Subject: REVISION: 18226-01 - Special Coverage  
Overheating of Fuel Relay or Motor Terminal  
Revised Service Procedure

Models: 2008-2011 Buick Lucerne  
2009-2011 Cadillac DTS

## 18226 Overheating of Fuel Relay or Motor Terminal

**Revision Description:** This bulletin is being revised to update the service procedure. Please discard all previous copies of 18226.

### Rear Seat Bracket Repair for Lucerne

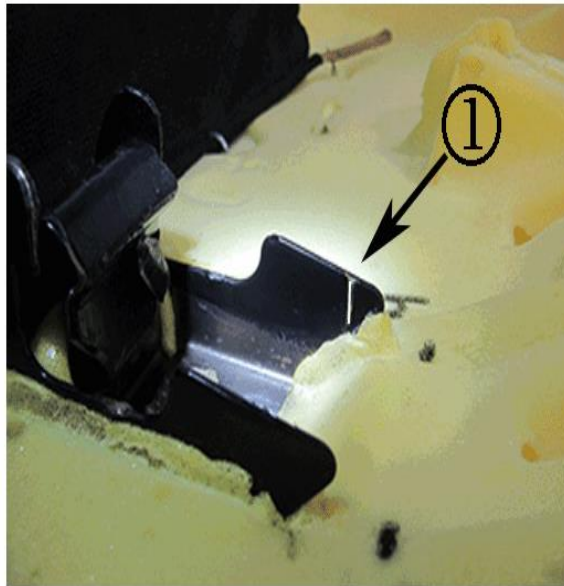
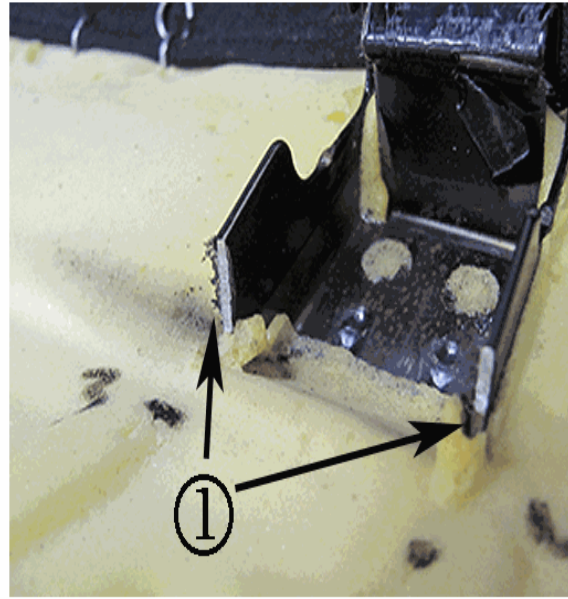
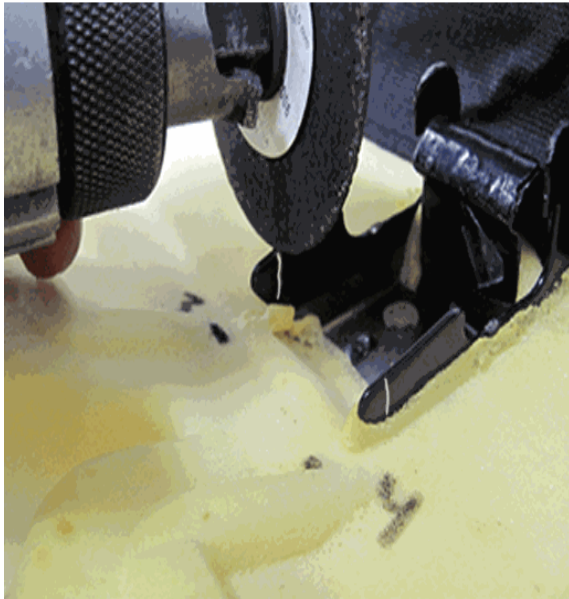
<b>Correction</b>	Dealers are to inspect and if repair is necessary, replace the rear electrical center (REC). Additional repairs to the fuel pump relay wiring may be required. In each case the rear seat bracket will need to be trimmed (Lucerne only). The repairs will be made at no charge to the customer.

1. With the rear seat cushion on a bench, measure 5 mm (0.197 in) from each edge of the right side seat mount bracket and mark with a paint marker as shown (1).

2. Using a cut off wheel or equivalent, carefully cut each side of the bracket as shown (1). Check for any rough edges and file if necessary.
3. Install the rear seat cushion.
4. Connect the battery.
